Access Compliance Report

Public Rights-of-Way

(Curb Ramps)

Intersection ID: 10034124	Main Street: PATRICIA_RYAN_DR	Cross Street: N/A	Location:	N
ADA ID: CE85442C5F70	Ramp Type: Perp	Initial Pass/Fail: Fail	Overall Compliance: No	Severity Score: 10
Codes/Mitigation Info/Possible Solution		Field Measurements/Component Compliance

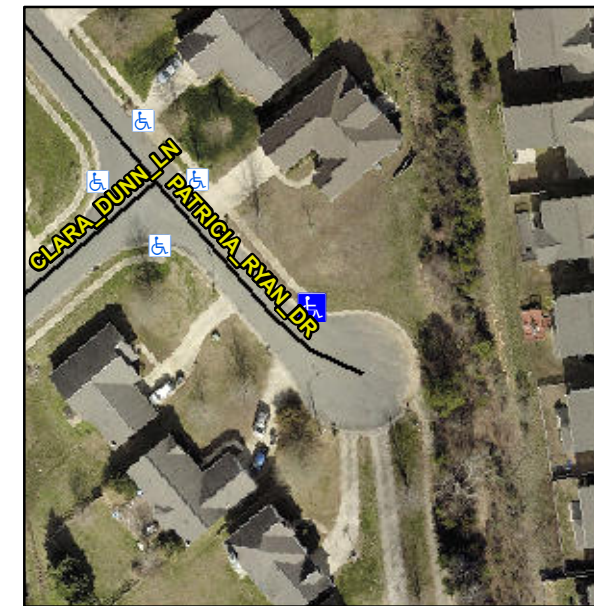
Not Found, R304.5.1, R304.5.3

Compliance	Description	Data	Compliance	Description	Data
N/A	Ramp Length (in)	46.5	Yes	Ramp Slope (%)	5.0
No	Ramp Width (in)	46.5	No	Ramp XSlope (%)	3.3
N/A	Flare Type LT	N/A	N/A	Flare Type RT	N/A
N/A	Flare Slope LT (%)	N/A	N/A	Flare Slope RT (%)	N/A
N/A	Flare Traversable LT?	N/A	N/A	Flare Traversable RT?	N/A
N/A	Landing Length (in)	N/A	N/A	DWS Provided?	N/A
N/A	Landing Width (in)	N/A	N/A	DWS Contrast?	N/A
N/A	Landing Slope (%)	N/A	N/A	DWS Length (in)	N/A
N/A	Landing X Slope (%)	N/A	N/A	DWS Full Width?	N/A
N/A	Landing Curb? (Y/N)	N/A	N/A	DWS Offset (in)	N/A
N/A	Shared Landing?	N/A			
N/A	Gutter Ponding?	N/A	N/A	Gutter Slope (%)	N/A
N/A	Gutter Lip Ht (in)	N/A	N/A	Gutter X Slope (%)	N/A
N/A	Painted X Walk1?	No	N/A	Painted X Walk2?	N/A
	X Walk 1 Direction	To W		X Walk 2 Direction	N/A
N/A	X Walk 1 Width (in)	N/A	N/A	X Walk 2 Width (in)	N/A
	X Walk 1 Slope (%)	1.3		X Walk 2 Slope (%)	N/A
	X Walk 1 X Slope (%)	3.1		X Walk 2 X Slope (%)	N/A

Remove & Replace Entire Ramp.
